# Access Compliance Report

## Public Rights-of-Way (Curb Ramps)

Intersection ID: 2890	Main Street: BROKEN_PINE_LN	Cross Street: EVERGREEN_HOLLOW_DR	Location: SW
ADA ID: 900ABC9348CE	Ramp Type: BlendTrans2	Initial Pass/Fail: Fail	Overall Compliance: No
Severity Score: 15			
Codes/Mitigation Info/Possible Solution		Field Measurements/Component Compliance

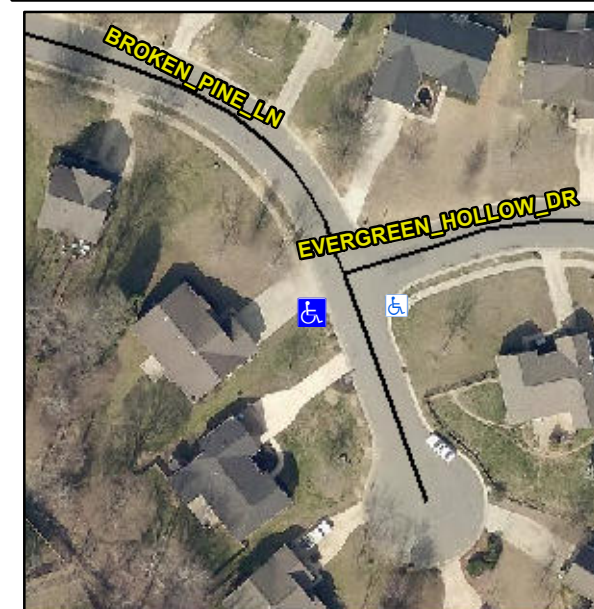
**Not Found, R302.7**

Compliance	Description	Data	Compliance	Description	Data
N/A	Ramp Length (in)	95.0	Yes	BlendTrans Slope (%)	3.3
Yes	Ramp Width (in)	99.0	Yes	BlendTrans XSlope (%)	0.0
N/A	Flare Type LT	N/A	N/A	Flare Type RT	N/A
N/A	Flare Slope LT (%)	N/A	N/A	Flare Slope RT (%)	N/A
N/A	Flare Traversable LT?	N/A	N/A	Flare Traversable RT?	N/A
N/A	Landing Length (in)	N/A	N/A	DWS Provided?	N/A
N/A	Landing Width (in)	N/A	N/A	DWS Contrast?	N/A
N/A	Landing Slope (%)	N/A	N/A	DWS Length (in)	N/A
N/A	Landing X Slope (%)	N/A	N/A	DWS Full Width?	N/A
N/A	Landing Curb? (Y/N)	N/A	N/A	DWS Offset (in)	N/A
N/A	Shared Landing?	N/A			
N/A	Gutter Ponding?	N/A	N/A	Gutter Slope (%)	N/A
N/A	Gutter Lip Ht (in)	N/A	N/A	Gutter X Slope (%)	N/A
N/A	Painted X Walk1?	No	N/A	Painted X Walk2?	N/A
	X Walk 1 Direction	To E		X Walk 2 Direction	N/A
	X Walk 1 Width (in)	N/A		X Walk 2 Width (in)	N/A
	X Walk 1 Slope (%)	5.4		X Walk 2 Slope (%)	N/A
	X Walk 1 X Slope (%)	3.6		X Walk 2 X Slope (%)	N/A

N/A	Ramp inside XWalk1?	N/A	N/A	Ramp inside XWalk2?	N/A
	Road Slope (%)	3.6		Clear Space?	N/A
	Road X Slope (%)	5.4	N/A	Clear Space to XWalk (in)	N/A
N/A	Any Obstructions?	N/A	N/A	Storm Grate/Utility Hazard?	N/A
	Obstruction Type			Storm Grate/Utility Type	
		N/A			N/A
		No		Surface Condition? (G/P)	Poor
		No		Curb Slope (%)	5.7

**Remove & Replace Curb Ramp With Two New Directional Ramps or Equivalent.**
